Backfeed v250

Changelog:

v250 Changes:

Figure 145–29a — Reflected voltage requirements

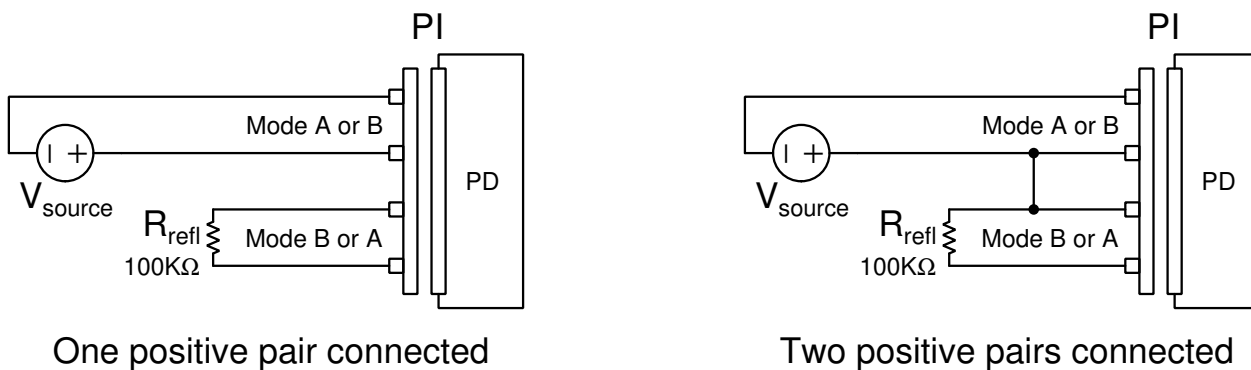
145.3.8.8 ~~Backfeed~~ Reflected voltage

Replace the contents of 145.3.8.8 as follows:

For a single-signature PD, when any voltage in the range of 0 V to $V_{Port,PD-2P}$ max is applied per any of the valid 2-pair configurations, defined in Table 145–20, that have only a single pair connected to positive V_{PSE} (see Figure 145–29a), the voltage on the Mode not connected to the voltage source, with a 100 k Ω resistor connected across that Mode, shall not exceed V_{refl} as defined in Table 145–29.

For a single-signature PD, when any voltage in the range of 0 V to 10.1 V is applied per any of the valid 2-pair configurations, defined in Table 145–20, including those with two pairs connected to positive V_{PSE} (see Figure 145–29a), the voltage on the Mode with at least one pair not connected to the voltage source, with a 100 k Ω resistor connected across that Mode, shall not exceed V_{refl} as defined in Table 145–29. This requirement does

not apply if a voltage greater than 10.1 V has been applied on either Mode until the voltage on both Modes has been less than V_{Reset} for at least T_{Reset} .

For a dual-signature PD, when any voltage in the range of 0 V to $V_{\text{Port.PD-2P max}}$ is applied per any of the valid 2-pair configurations, defined in Table 145–20, including those with two pairs connected to positive V_{PSE} (see Figure 145–29a), the voltage on the Mode with at least one pair not connected to the voltage source, with a 100 k Ω resistor connected across that Mode, shall not exceed V_{refl} as defined in Table 145–29.
